Amendment to the Drawings:

Title of Invention: ACTIVE MATRIX ORGANIC LIGHT EMITTING DIODE FLAT PANEL DISPLAY
Inventor: Ronald S. Cok; USSN: 09/858,109

FIG. 1
(PRIOR ART)

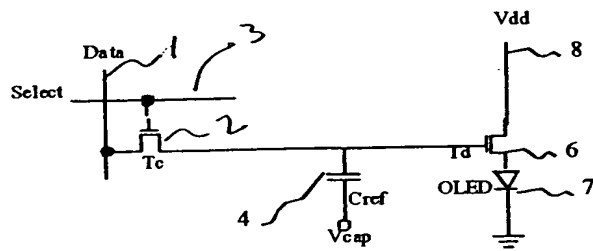
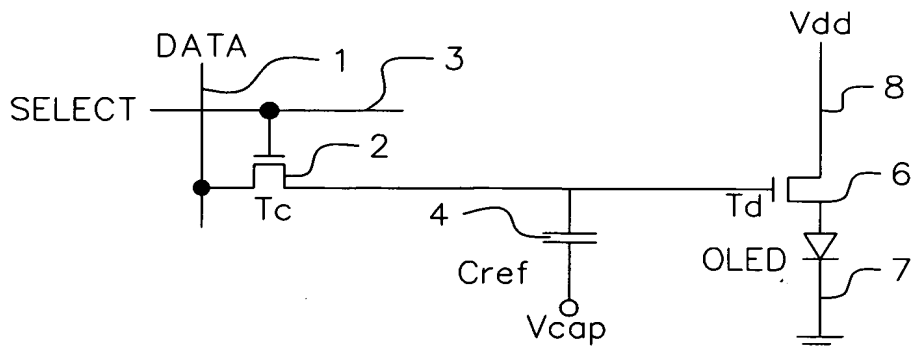
The attached sheet of drawings includes changes to Figure 1 (Fig. 1)
This sheet replaces the original Fig. 1. Formal drawings are submitted herewith under
separate Letter to the Draftsperson which incorporate the changes required by the
Examiner. Approval by the Examiner is respectfully requested.
